MILITARY SPECIFICATION

MODULES, STANDARD ELECTRONIC

GATE, AND-OR-INVERT, DIGITAL, KEY CODE LHJ

This amendment forms a part of Military Specification MIL-M-28787/64A(EC), dated 1 May 1980, and is approved for use by the Naval Electronic Systems Command, Department of the Navy, and is available for use by all Departments and Agencies of the Department of Defense.

FIGURE 6. V_{OUT} (low-loaded) test circuit for table IV.

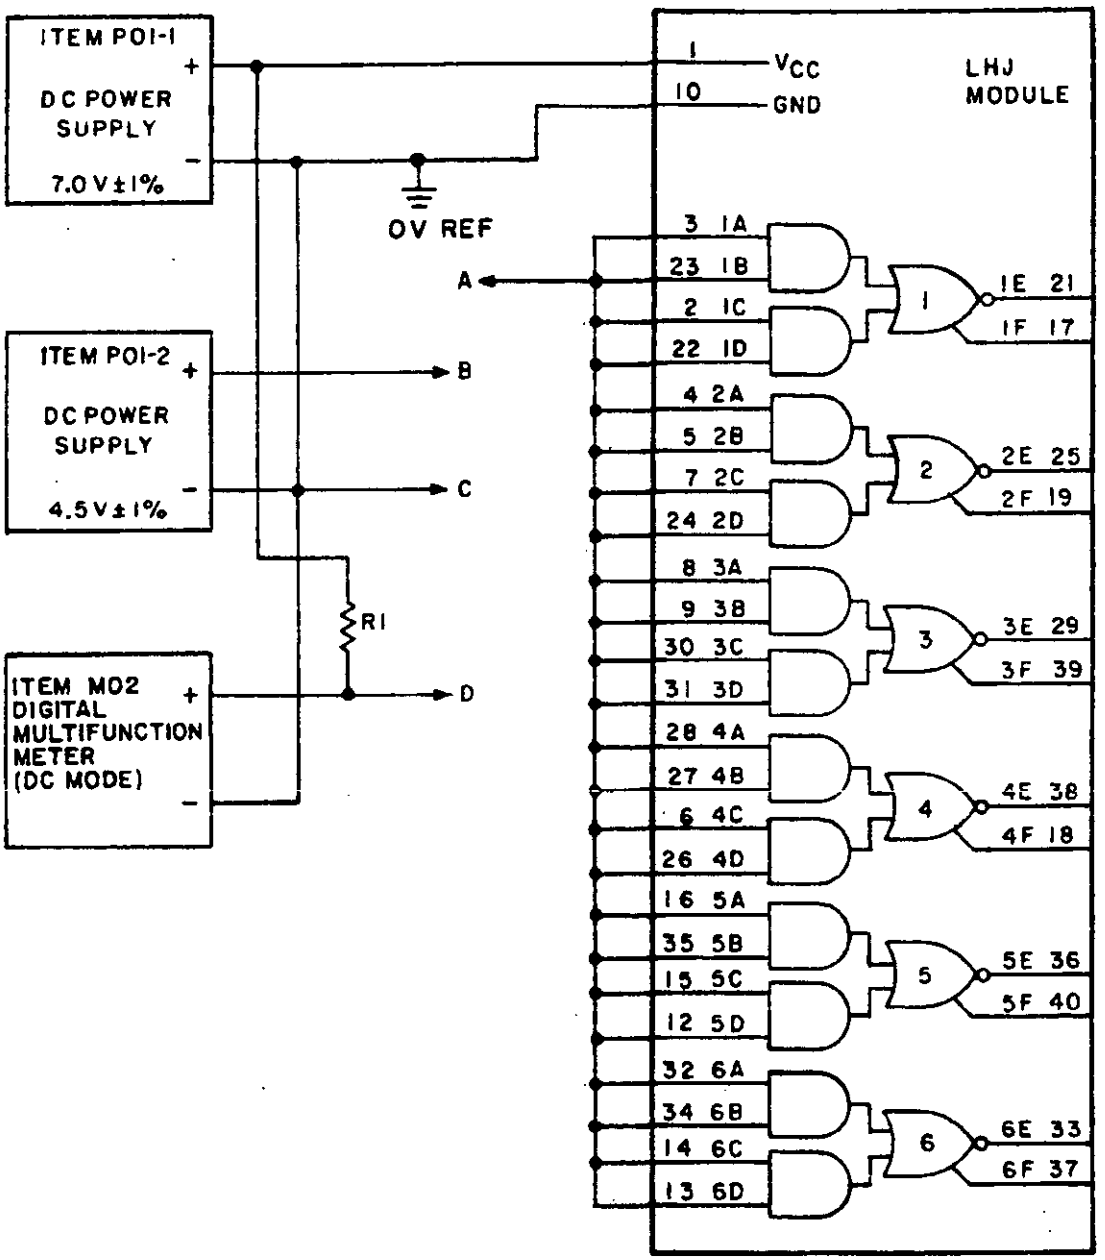
FIGURE 6: Delete and substitute new figure 6 as printed on page 3 of this amendment.

NOTE: R1 = 249Ω ±1%, 1/4 W.

FIGURE 10. Input clamp diode voltage test circuit for table VIII.

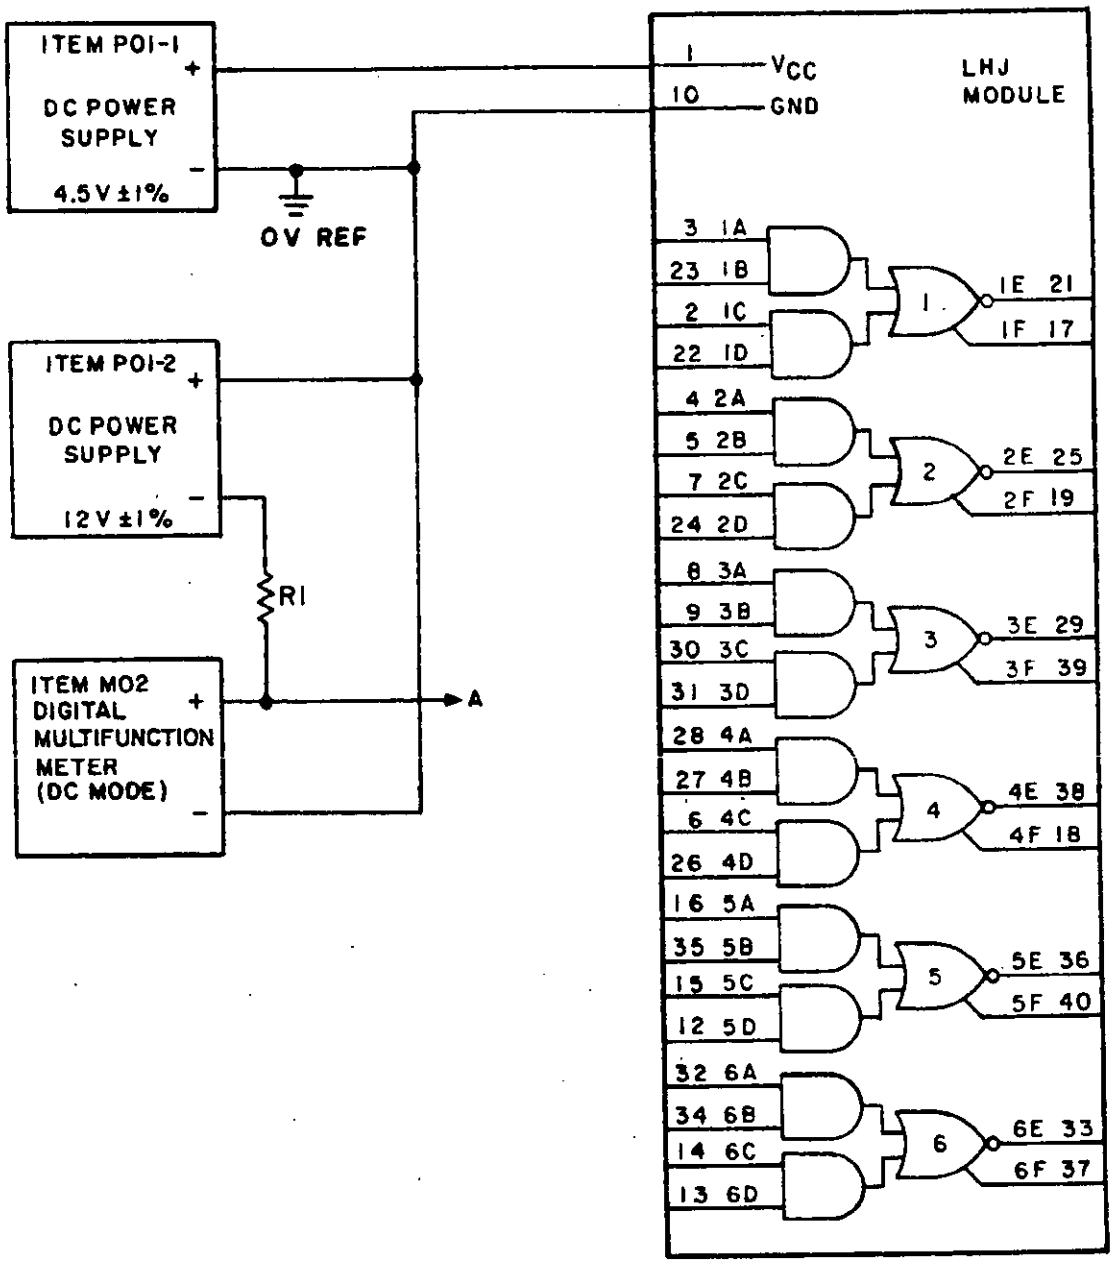
FIGURE 10: Delete and substitute new figure 10 as printed on page 4 of this amendment.

NOTE: R1 = 590Ω ±1%, 1/4 W.

FIGURE 11. Static output voltage (high-level and low-level) test circuit for table IX.

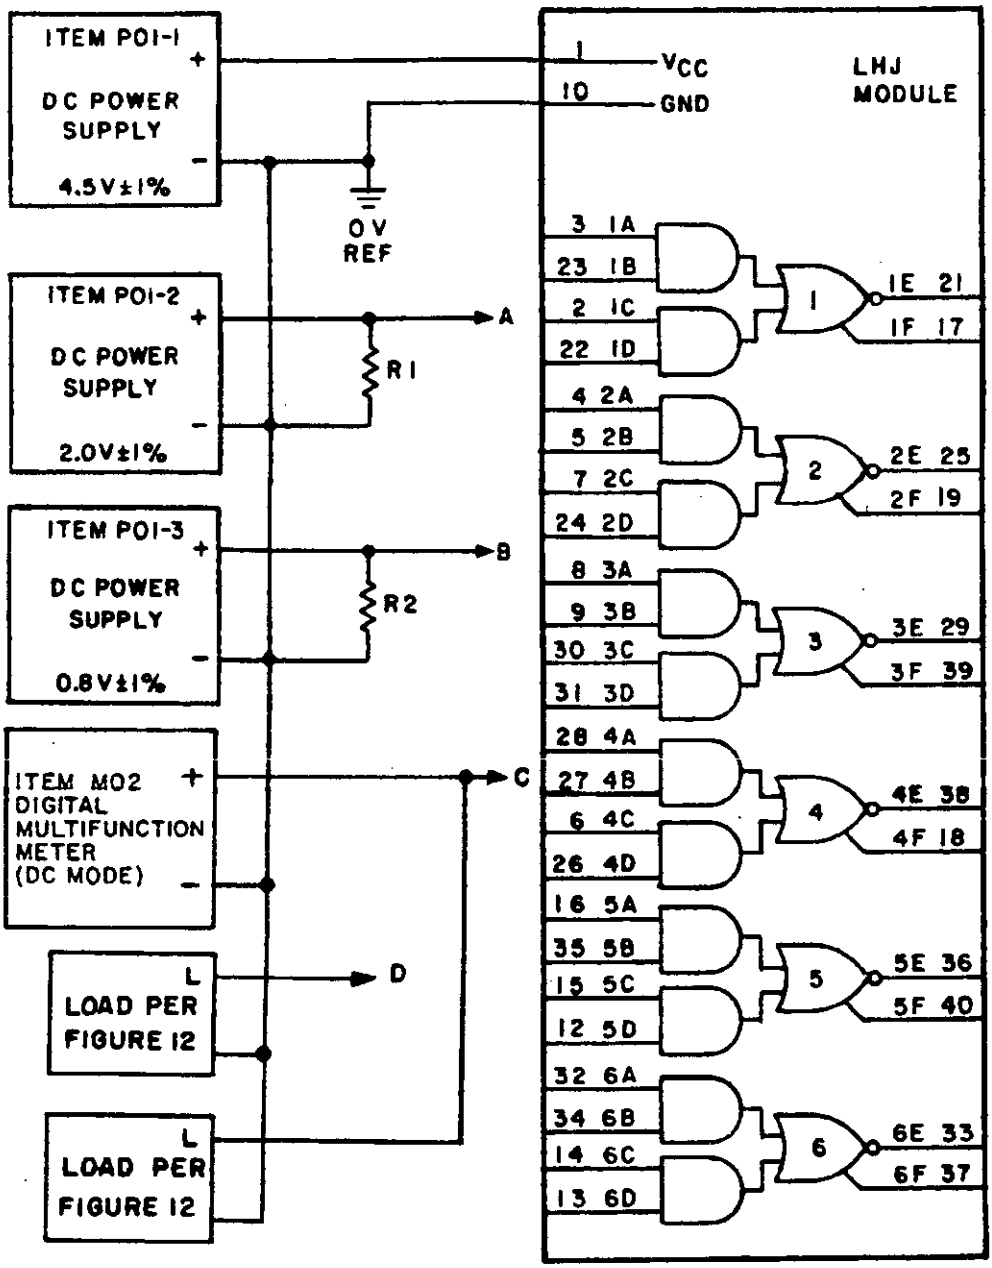
FIGURE 11: Delete and substitute new figure 11 as printed on page 5 of this amendment.

NOTES:
1. R1 = R2 = 51Ω ±5%, 1/2 W.
2. Both outputs of the circuit under test shall be loaded simultaneously per figure 12.

FIGURE 13. Functional test circuit for table X.

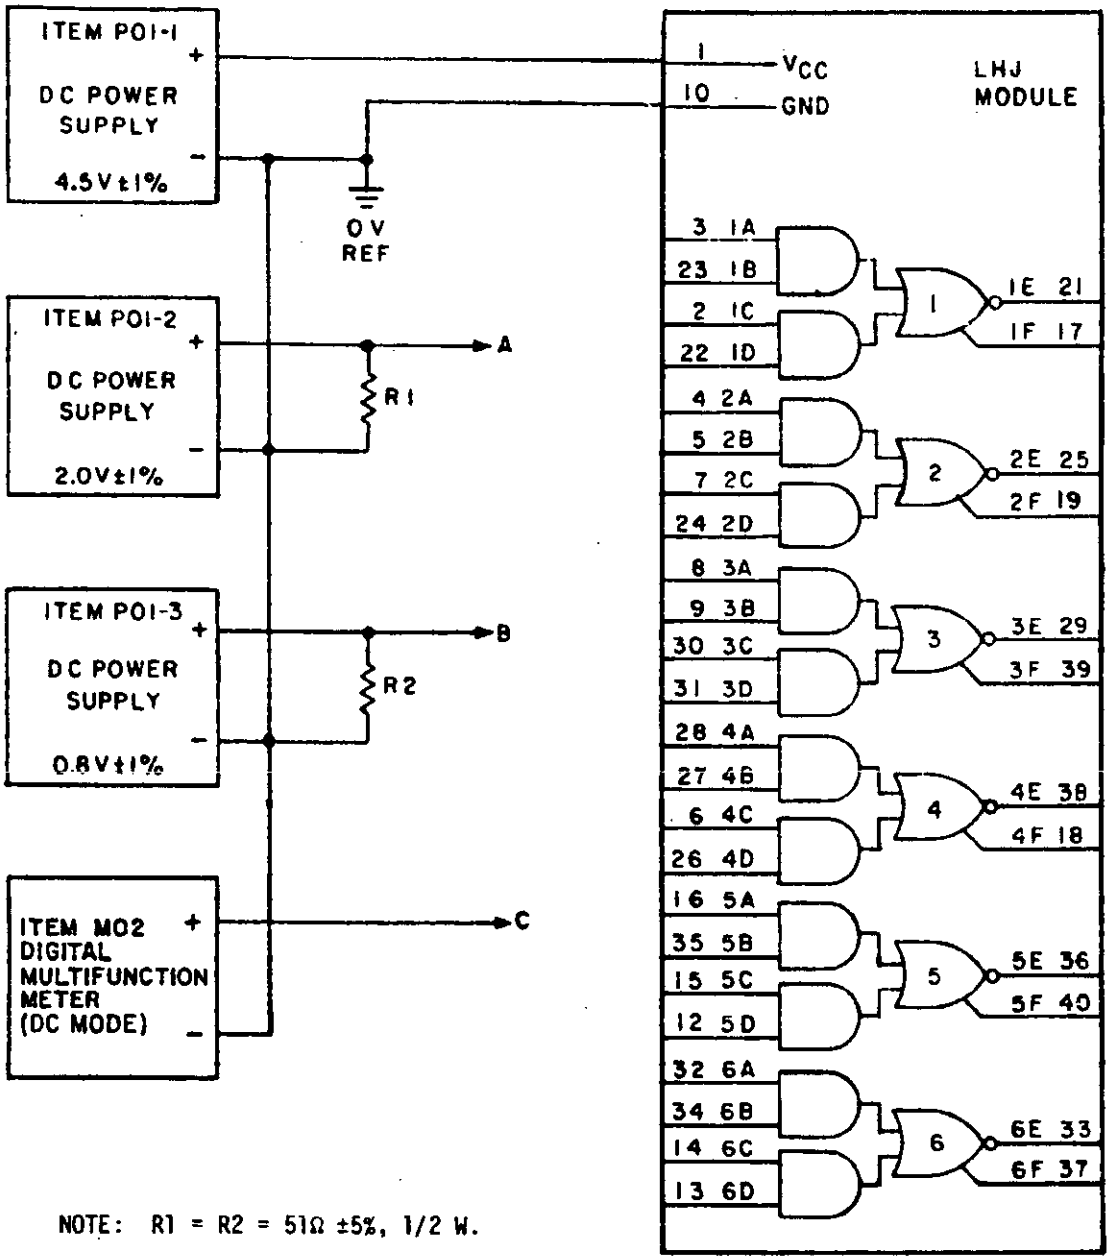
FIGURE 13: Delete and substitute new figure 13 as printed on page 6 of this amendment.

NOTE: R1 = R2 = 51Ω ±5%, 1/2 W.
